Review of the Three Lakes Water Quality Model and the Colorado-Big Thompson RiverWare Model, Colorado

Prepared for
United States Bureau of Reclamation
Great Plains Region
Eastern Colorado Area Office

October 2018

Figure 8: Granby historic Precipitation and Evaporation values, not currently used in the simulation

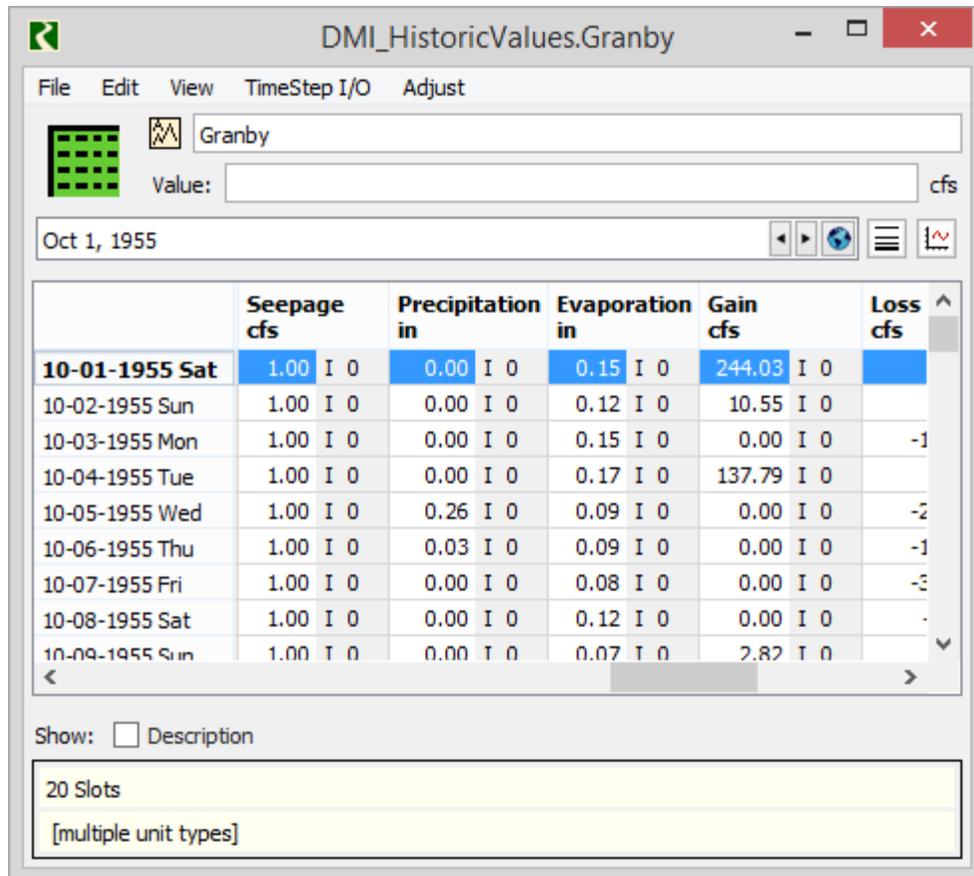
- Based on the analysis and data provided by Hydros, the Pan and Ice method would be more appropriate.
- Hydros also produced precipitation data that are not currently used in the model. A sample of these data are shown in Figure 8. (Precipitation is always zero in the model.)
- There are daily evaporation and precipitation rate values stored in the DMI_HistoricValues.Granby slot (are these the Hydros values?), but Evaporation and Precipitation should be explicit rates (in/day), not length (in). It is not clear if the evaporation values in this slot are raw pan evaporation, or if they are the values applying the pan coefficient.

- If using the values from the DMI_HistoricValues.Granby slot directly, and if they already incorporate the Pan Coefficient, the Input Evaporation method would be okay. The values would simply need to be transferred over to the input slots for the Evaporation and Precipitation method using initialization rules, similar to other historical inputs.

Figure 12: CarterDeliveries agg diversion site with Windy Gap water user at a higher priority than CBT (note that on the Carter Deliveries agg diversion site, the CBT water user is used, not CBT Irrigation)

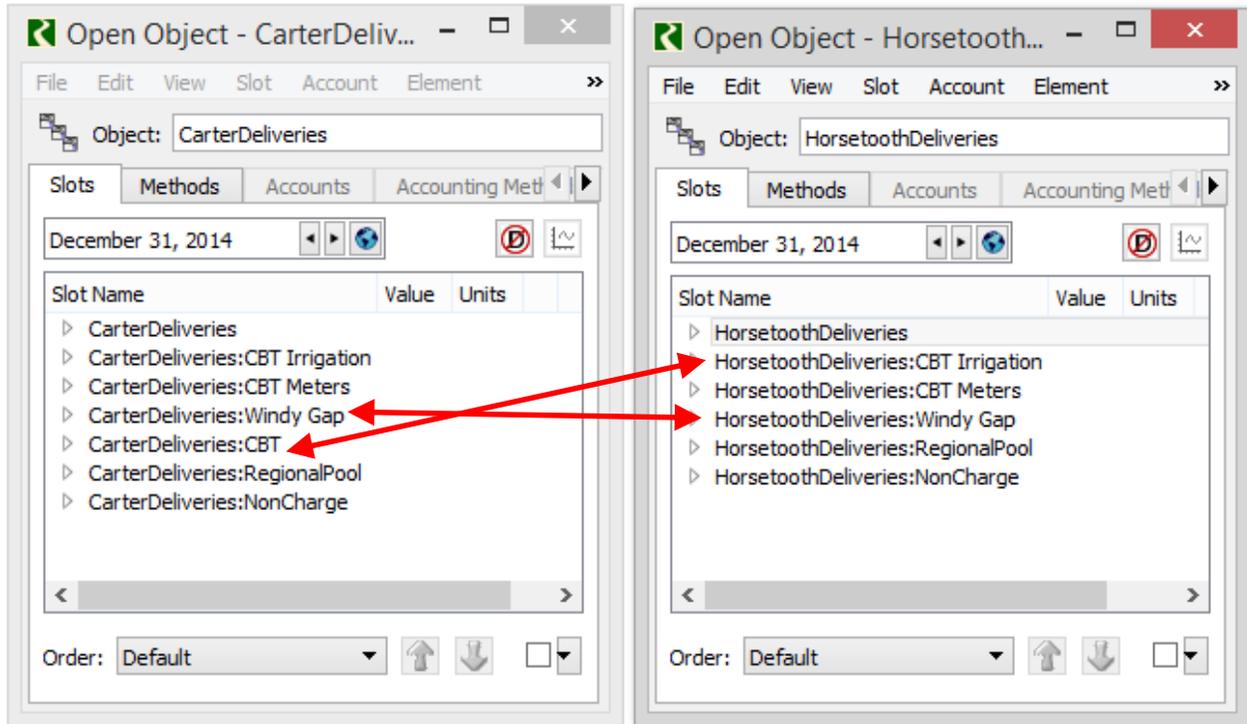
Windy Gap placement is above CBT in the sequential structure. This is inconsistent with the other Agg Diversion sites, which have CBT first. This changes their relative priorities for use of the water when there is a shortage (see Figure 12).

Figure 14: Daily Input Data.Inflows slot description, out of date

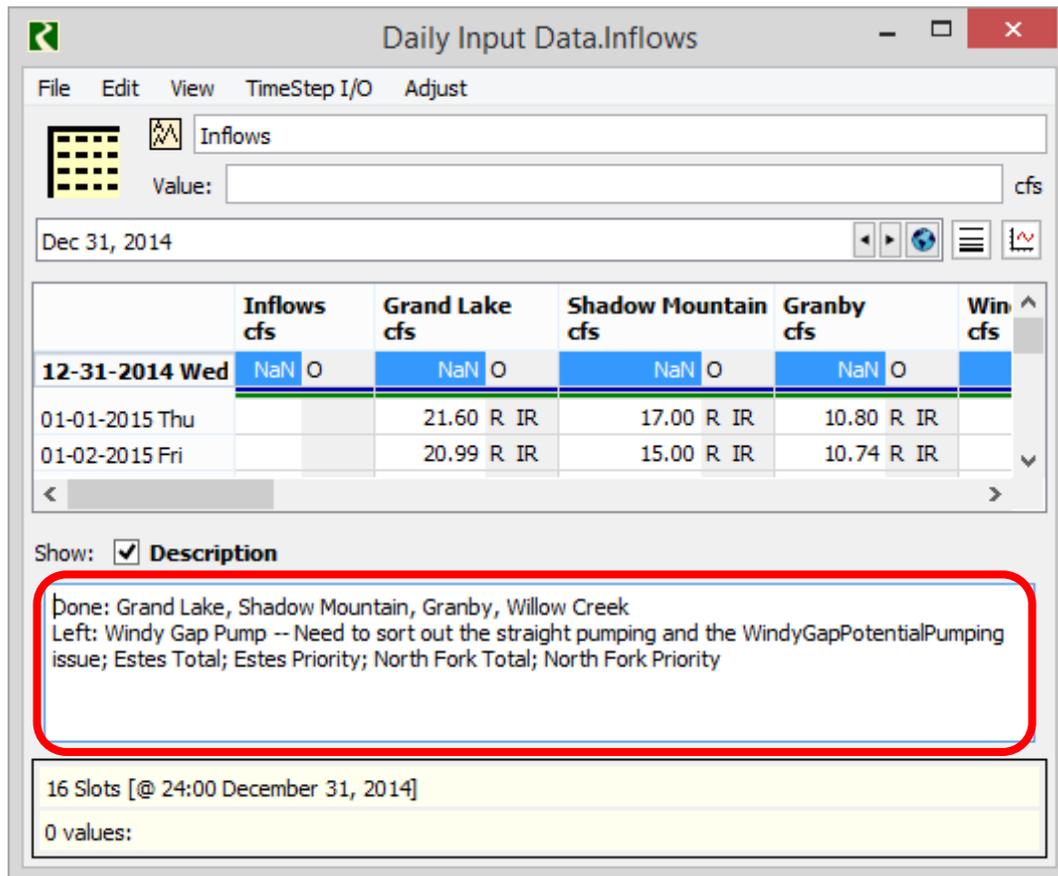
Within the slot Daily Input Data.Inflows, the description appears to be out of date (Figure 14).

Figure 20: EstimateTargetEvaporation function

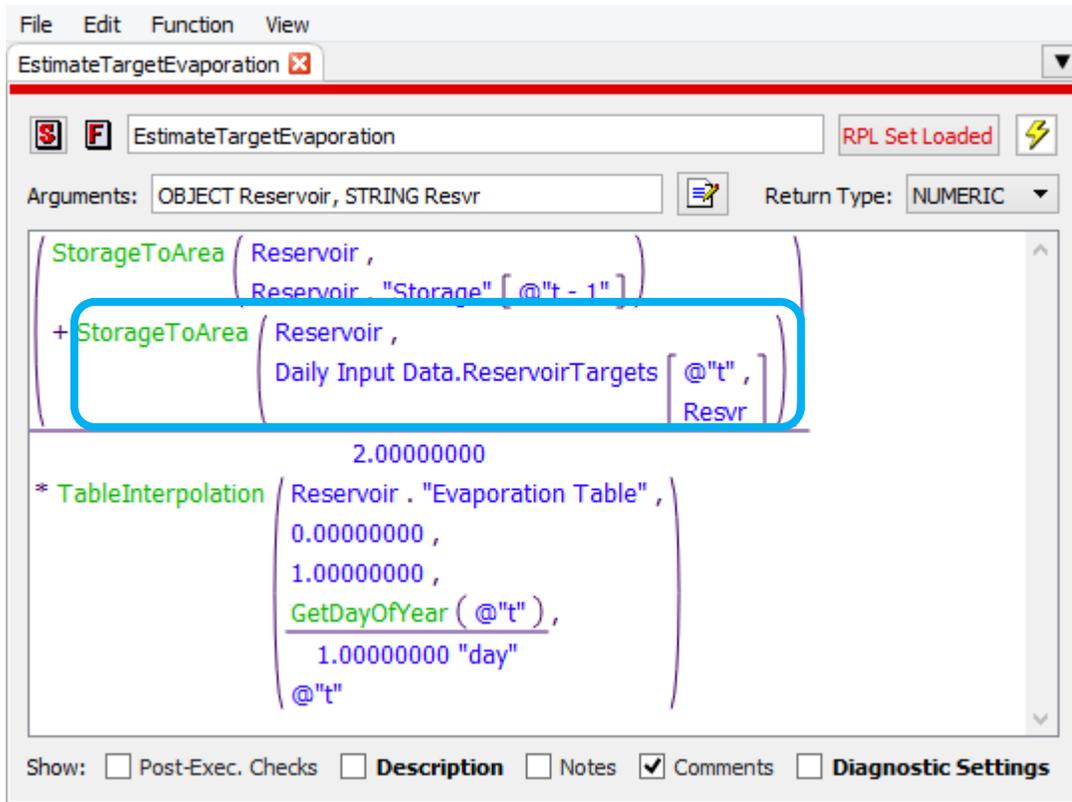
Rule 185: Set Initial West Slope Maximum Supplies – In the **EstimateTargetEvaporation** function (Figure 20), Storage[t-1] alone would be a better estimate for calculating evaporation at t than using the average with the target storage at t, especially for Granby where the storage can deviate

significantly from the target (the description in the rule acknowledges this potential issue).

Figure 24: CBTExchangeCapacity function, divides by the incorrect value

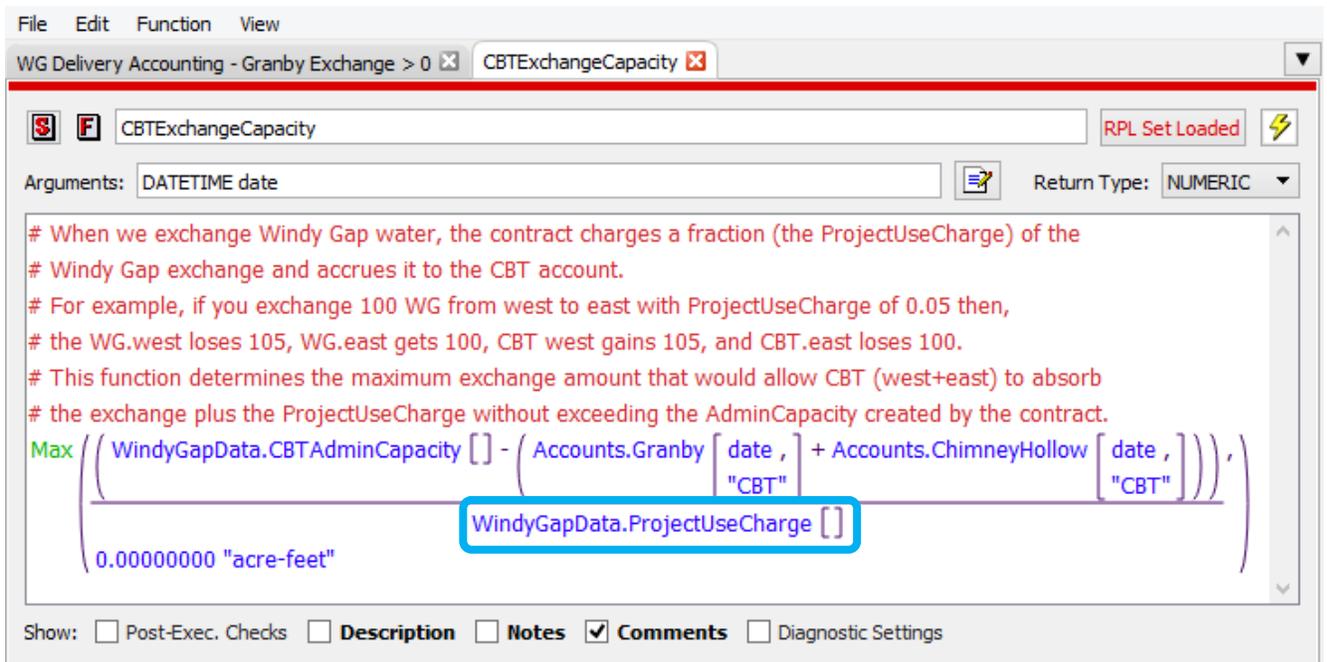
Rule 17: WG Delivery Accounting – Granby Exchange > 0 – The **CBTExchangeCapacity** function is incorrect. It should divide by $1+ProjectUseCharge$, not $ProjectUseCharge$ (Figure 24).

Figure 27: Grand Lake disaggregated inflow data on DMI_HistoricValues data object

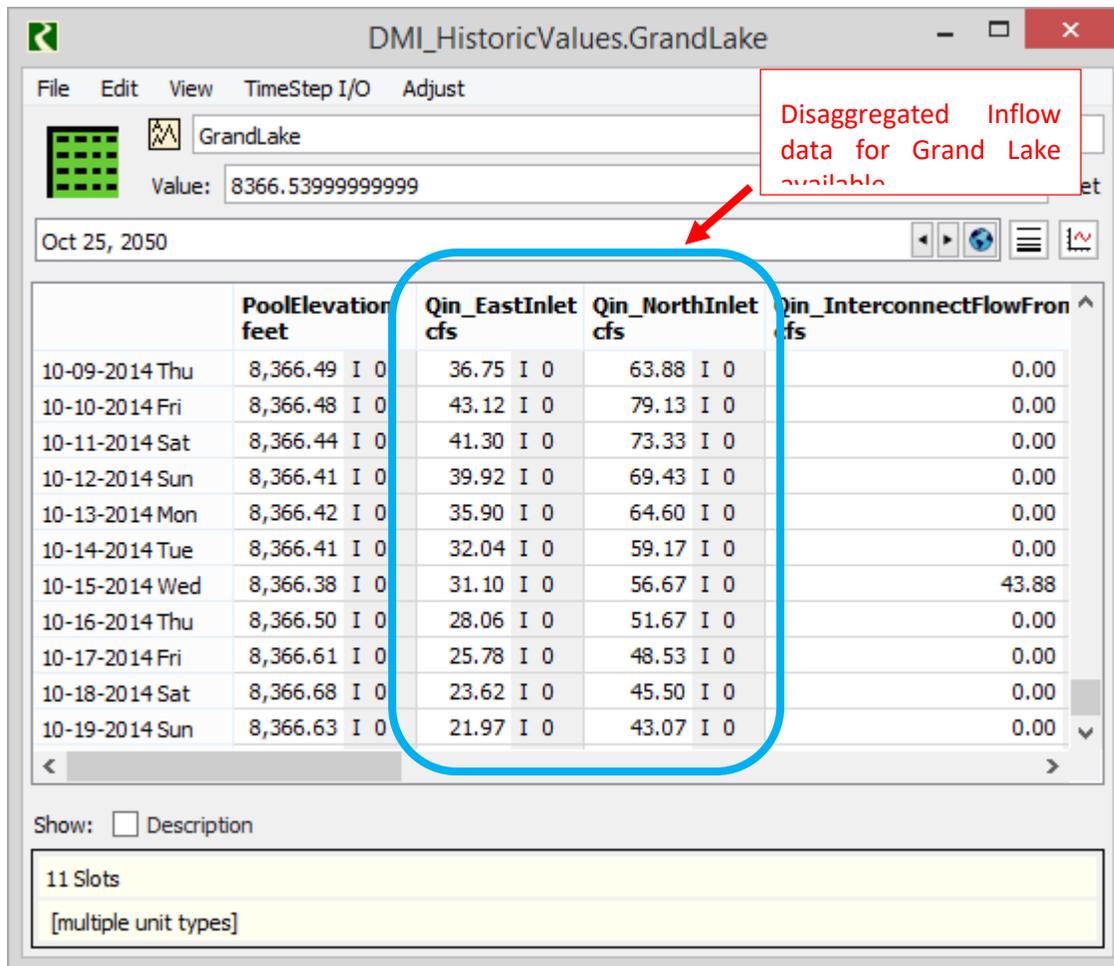
The Excel_WaterQualityInputs DMI was further reviewed as it provides input to the CE-QUAL-W2 model. The DMI appears to export the data necessary for the CE-QUAL-W2 model, but it would be useful for someone with CE-QUAL-W2 knowledge to make sure these are correct variables and map to the WQ model correctly. **One issue that raises a concern is that Grand Lake and Granby inflows exported by the DMI are the aggregated flows at fictitious gages in the RiverWare model and DMI. For example, EastNorthInlets represents the aggregated flows from both the East Inlet and North Inlet. Are these aggregated or disaggregated in the CE-QUAL-W2 model? We believe they should be disaggregated as the WQ model would require more resolution. It appears that the disaggregated inflow data are available in the model in the DMI_HistoricValues.Granby and DMI_HistoricValues.GrandLake agg series slots. See Figure 27 for more info.**

Figure 30: Average daily difference between the labeled day of month and the previous day. Because most the Arapaho data is imputed based off of monthly regressions, there is a bigger difference at the transition between months and other days.

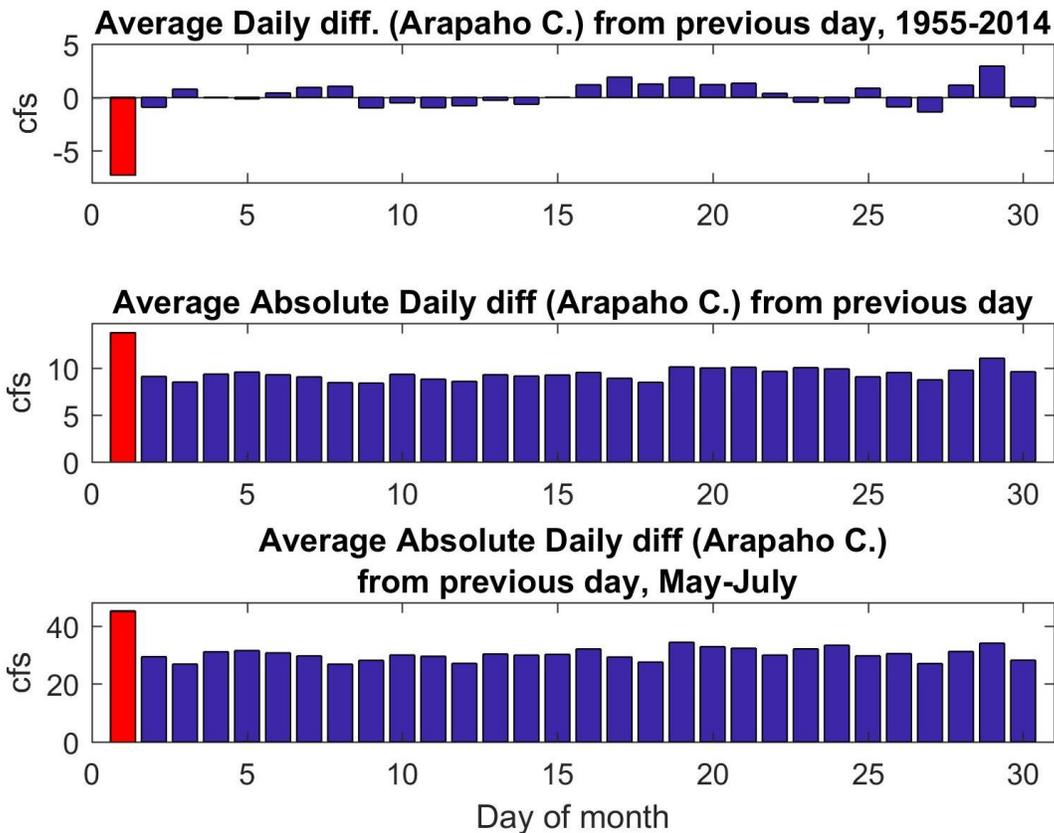
- 2) In general, a regression works best when there is a physical basis function. While applying different regressions for each month does capture seasonal variability, there is also a bit of arbitrariness to this decision that leads to some artifacts (why not use 20 days? 6 weeks?). As shown in Figure 30 below, the use of separate regressions for each month of the year results in a non-physical discontinuity between the first and last day of the month. Essentially, a slightly different statistical model with a slightly different slope and intercept is used, resulting in both an average and an absolute difference between the first and last day of each month. For Arapaho Creek, a negative bias is introduced on the first of the month that is greater than the value observed during other days of the month. The magnitude of the bias is largest during the spring freshet, when the average absolute flow difference is approximately 50% more than other days (Figure 30). We note that using a monthly regression model is preferable to using an annual model, since the processes producing discharge vary through the year. On the other hand, figuring out a way to reduce the “first-day” bias—e.g., by using monthly models that overlap each other in time, or by using some sort of weighted average—would be advisable. One way to test efficacy of any model would be to subdivide any statistical model into a ‘training data set’ and a ‘validation’ data set.

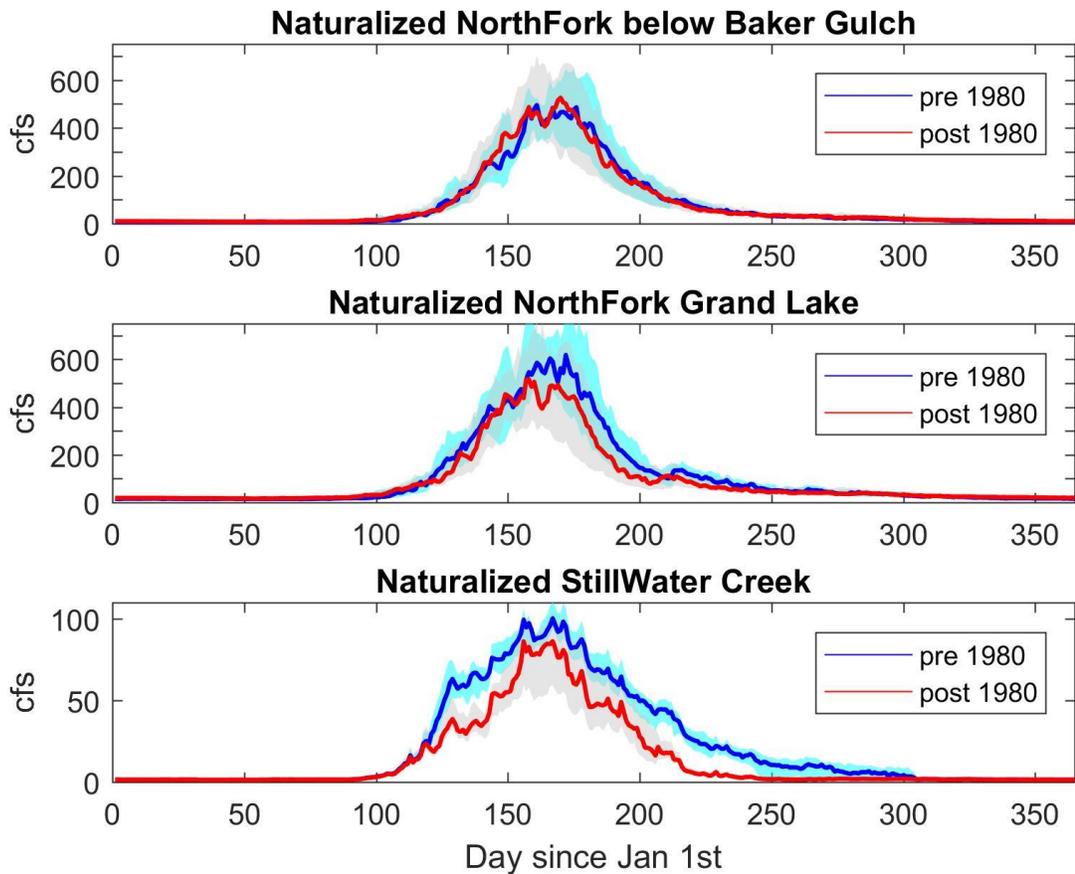
3) Naturalized flow data produced by imputation (or by adjusting measured data by accounting for withdrawals and additions) should be checked for consistency. A first assumption might be that statistics should be stationary between two time periods, unless climate change effects, natural variability or land-use patterns justify a change in hydrograph shape. However, our analysis of naturalized flow shows ambiguous results which may indicate problems with the underlying data. As shown in Figure 31 below, the naturalized hydrographs for the North Fork at Baker Gulch and Grand Lake do not agree with each other in terms of how peak timing and magnitude differed in the pre-and-post 1980 period, despite being fairly close to each other. The naturalized Stillwater creek hydrograph, which is almost entirely imputed, shows the most variability in the pre and post-1980 periods in terms of spring freshet timing and magnitude. Hence, based on these data, one might conclude that the Stillwater creek watershed exhibited non-stationarity over the past 60 years, whereas the North Fork at Baker Gulch did not. A physical explanation might be found, but a data issue is also possible. We recommend (a) determining the source of the divergence between hydrograph shapes pre and post 1980, since it may help explain some of the mass-balance corrections which are required to be applied to the RiverWare model and (b) determining, by other means such as precipitation measurements or snowpack, whether the system is statistically stationary or not. In other words, should one expect a non-stationary hydrograph that looks more like Stillwater Creek or should the system exhibit approximate stationarity, as at Baker Gulch? If this methodology is applied to all the different “naturalized” inflows to the system, one might be able to identify whether there are

any systematic biases over time. Or, stated differently, the variable “undepleted inflow total” in Miscellaneous.csv suggests a difference in the timing and magnitude of the peak freshet pre and post 1980 (Figure 32). Is this correct? If not, then there is a bias in the total flow.

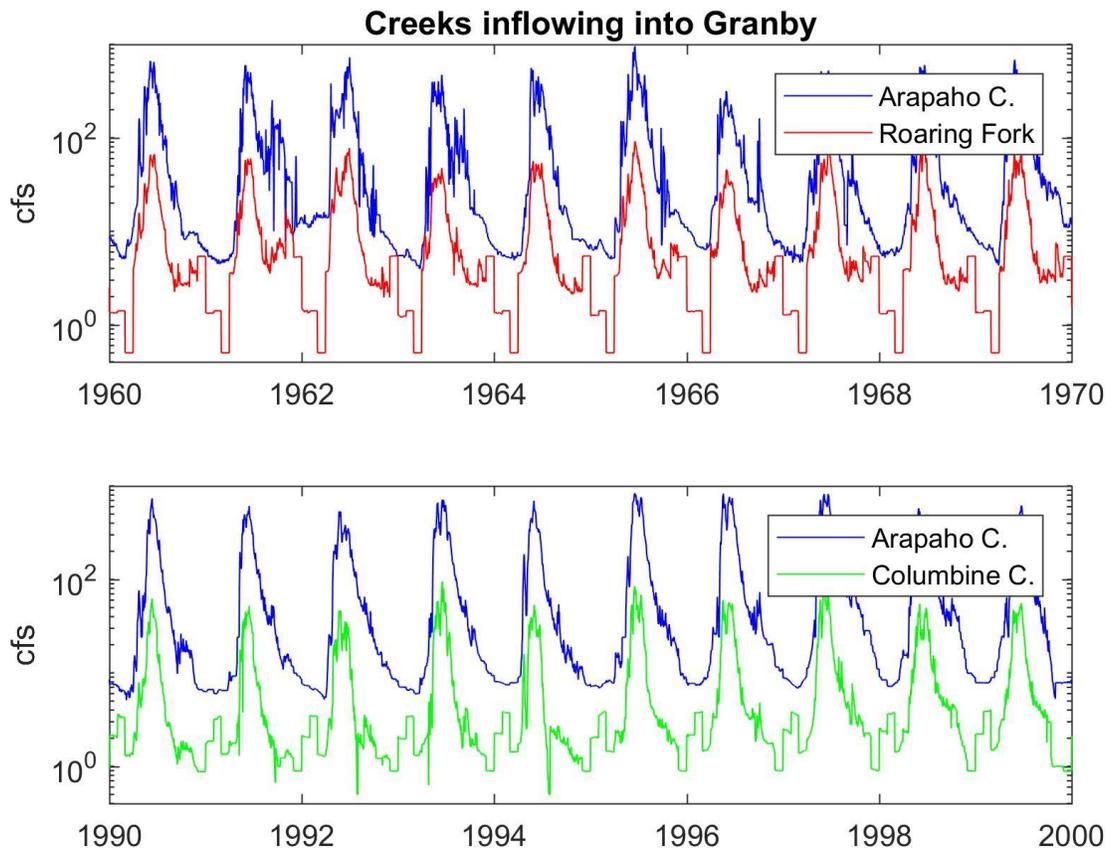
- 4) Some of the creeks flowing into the reservoirs have unrealistic hydrographs or unexplained features, as shown in Figure 33 below. The most obvious is the stair-case type profile that is observed during low flow conditions, probably as a result of using monthly averages. We note however that there is an unexplained maximum during the low flow periods that is at a different time between Columbine and Roaring Fork creeks, at least in the plotted data. Neither of these maxima is reproduced in Arapaho data. Similarly, a few extreme low flows are estimated for Columbine Creek, likely at the junction between daily interpolation and monthly averaged flows. Because the relative magnitudes of these low-season fluctuations are small, it is possible that it doesn't matter much in the overall mass balance; however, if possible it would be good to quantify the effect and determine whether a better estimate of the flow rate during these time periods can/should be made. It might be advisable to actually gage these flows, if they turn out to be a source of significant uncertainty.
